DEVELOPMENT DETERMINATION PANEL MEETING

WEDNESDAY 23 OCTOBER 2019

ITEM 3.1 MOD2019/0110 - 4 PANIMA PLACE, NEWPORT - MODIFICATION OF DEVELOPMENT CONSENT N0057/16 GRANTED FOR ALTERATIONS AND ADDITIONS TO EXISTING DWELLING AND THE RECONSTRUCTION OF EXISTING SWIMMING POOL

APPLICATION FOR MODIFICATION ASSESSMENT REPORT

Figure 1. Additional Building Height in green (9.6m) and previously approved RL17.88 with modified RL17.95.

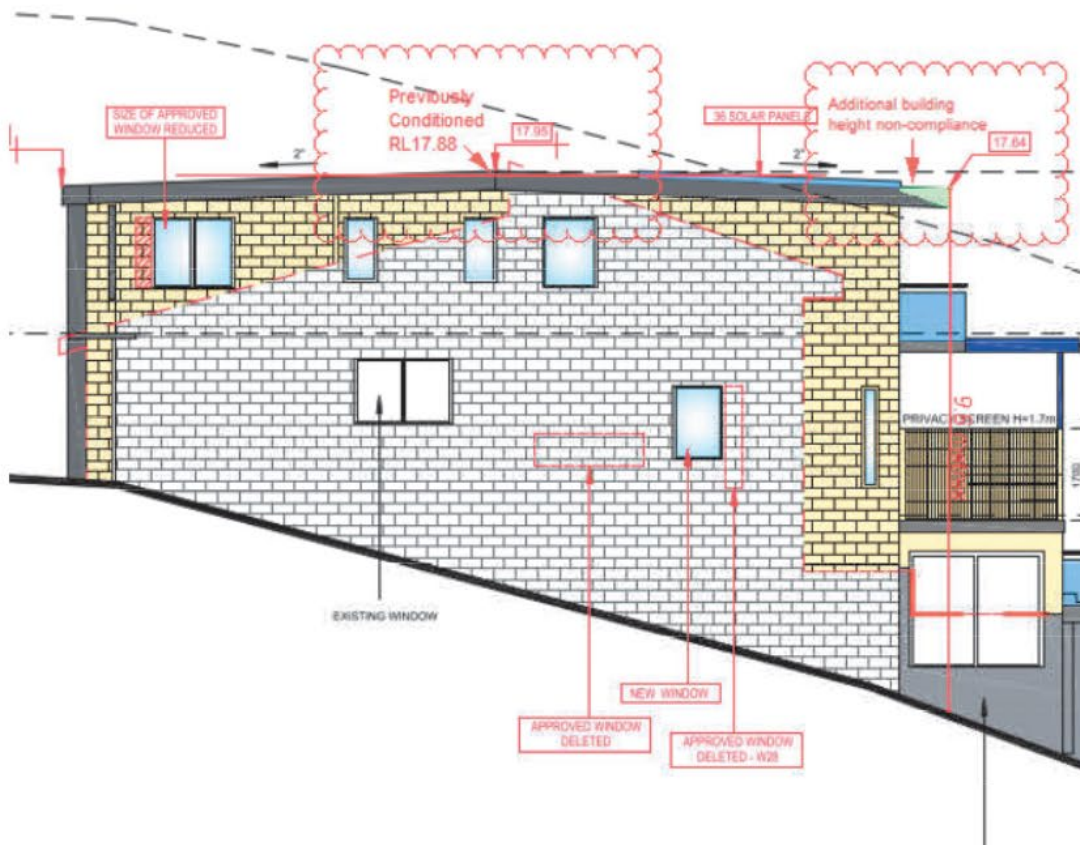
The modification seeks to vary the building height to 9.6m, with an increase in the maximum roof ridge from RL17.88 to RL17.95 (an increase of 0.07m or 70mm as shown in Figure 1 below).

It is important to note that the maximum roof ridge of RL17.95 (apex of the roof) complies with the 8.5m building height standard as shown in the diagram.

The additional building height non-compliance is located at the north-eastern corner of the northern roofline edge over the balcony of the first floor.

Figure 2. Pink area represents the visual bulk and scale created by 1.8m privacy screens.

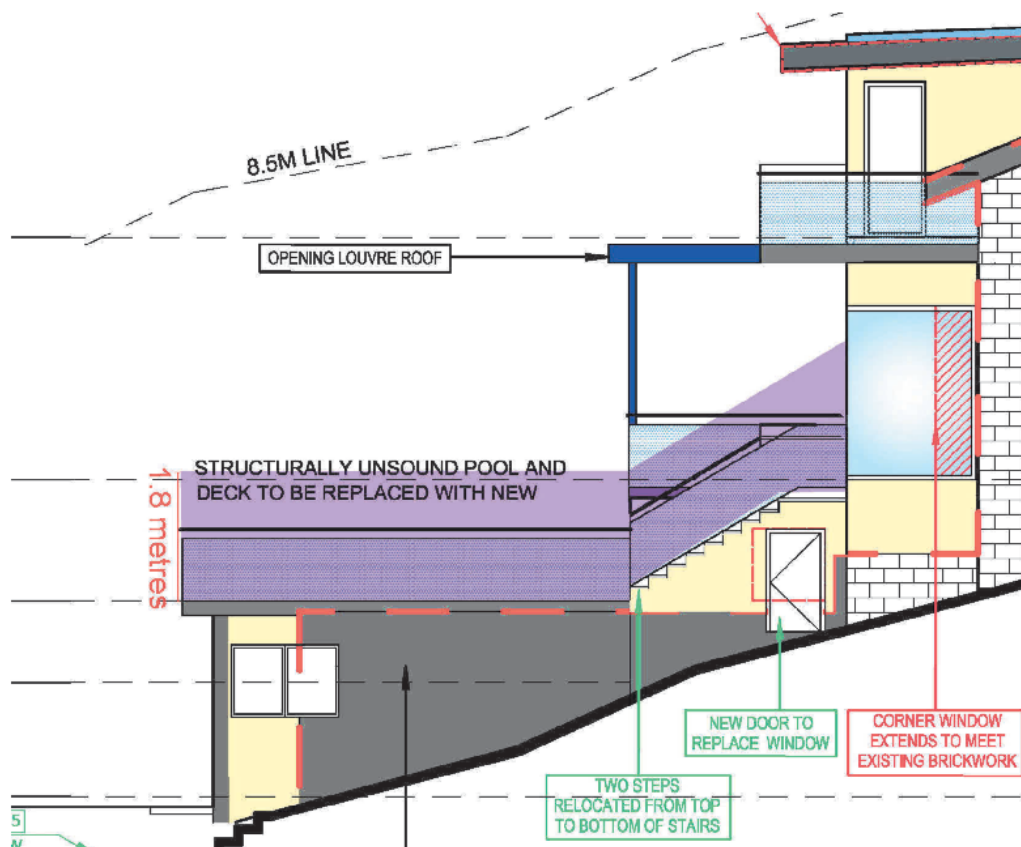
As discussed, the installation of a privacy screen on the western elevation terrace area would impact the view line for all properties. Therefore, it is considered reasonable not to incorporate a privacy screen on the pool deck so to maintain existing view lines.

The addition of a 1.8m privacy screen, as requested by No.3 Panima Place, would significantly add to the bulk and scale of the built form, as shown by figure 2 below. Privacy screens would not demonstrate a skilful approach to managing the visual privacy as a result of the slope, with a visual presentation being an un-modulated structure on the western elevation that presents as a massing of bulk and scale. This presentation is not consistent with the desired character of the Newport Locality, nor Clause D10.18 (Scenic Protection Category One Areas) where bulk and scale are to be minimised to ensure the preservation of scenic views and encourage view sharing.

Figure 2: Additional envelope encroachment in as a result of the modification in green.

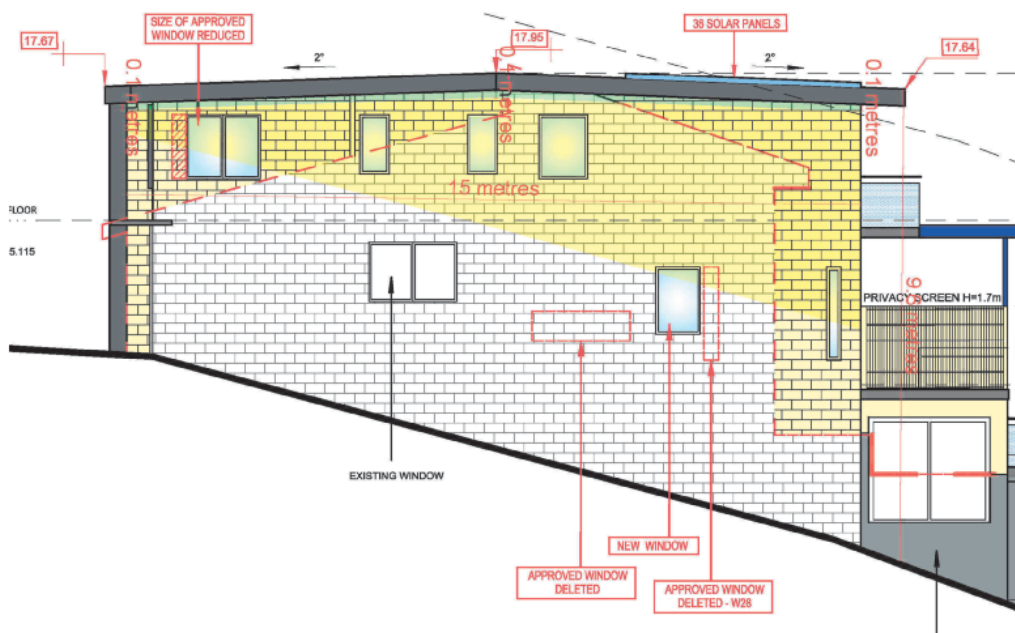
The control permits a minor variation for the addition of a second storey where the existing dwelling is retained. The proposed modified works continue to include the retention of the existing dwelling with a first floor level, and as such the modified variation for the addition of a second storey is permitted.

The non-compliance reflect the transitions within the existing ground line combined with the additional building height as shown by Figure 2 below. The resulting built form is not considered unreasonably bulky or dominant and will be suitably in scale with the large trees that exist on the site.

The proposed works are considered to be reasonable solution in light of the circumstances, the constraints of the site and is consistent with the outcomes of the building envelope control, as follows:

D. Add Condition 17B Obstruction of Access Path to read as follows:

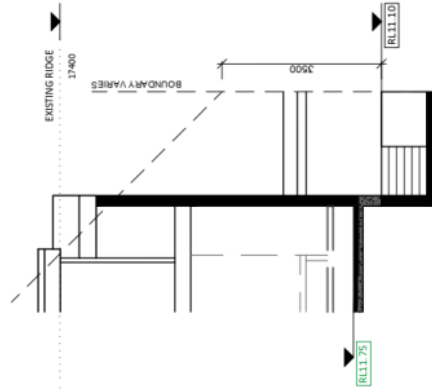
During the demolition and construction phase, no construction materials are to obstruct the access path between No.4 Panima Place and No.3 Panima Place. Additionally, all construction fences are to be located on or within the property boundaries.

Reason: to ensure that access is not obstructed to the neighbouring sites
